Sand Creek Center Tributary Channel Improvements
Initial Corps direction is to apply for a

The purpose of this letter is to provide design information for the existing conditions of the Sand Creek Center Tributary Drainageway, located east of the Solace Apartments site. This letter will also discuss the proposed improvements for the channel, design methodology, and the modeling results. For further information on the previous evaluation of the channel in its existing conditions and conceptual design, see the Sand Creek – Center Tributary Channel Analyses Report for Solace Apartments by JR Engineering. For further information concerning drainage for the Solace Apartments Site, see the Final Drainage Report for Solace Apartments, by JR Engineering.

SOLACE APARTMENTS - SAND CREEK CENTER TRIBUTARY

CHANNEL IMPROVEMENTS

Figure 8.3. USBR Type III Stilling Basin

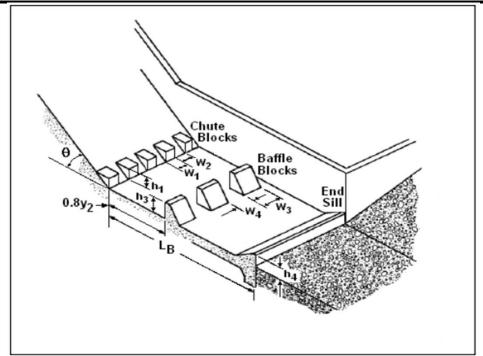
The details only indicate 2 chute blocks. Please revise the details and/or calcs accordingly.

Figure 8.3. USBR Type III Stilling Basin

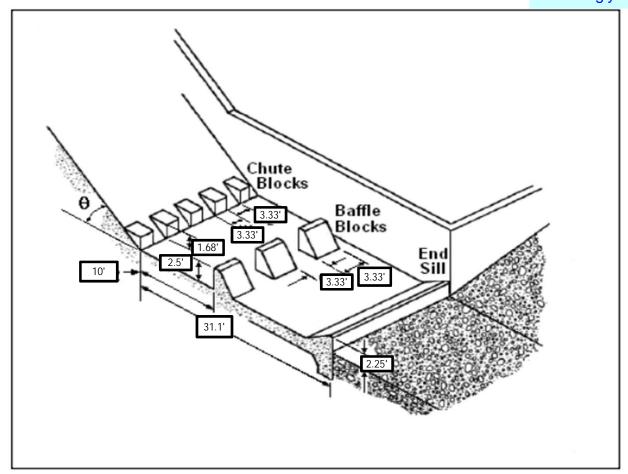
the spacing on the

54926 Revise accordingly.

detail indicates 1.33'.

Only 2 baffle blocks are indicated on the detail. Revise accordingly.
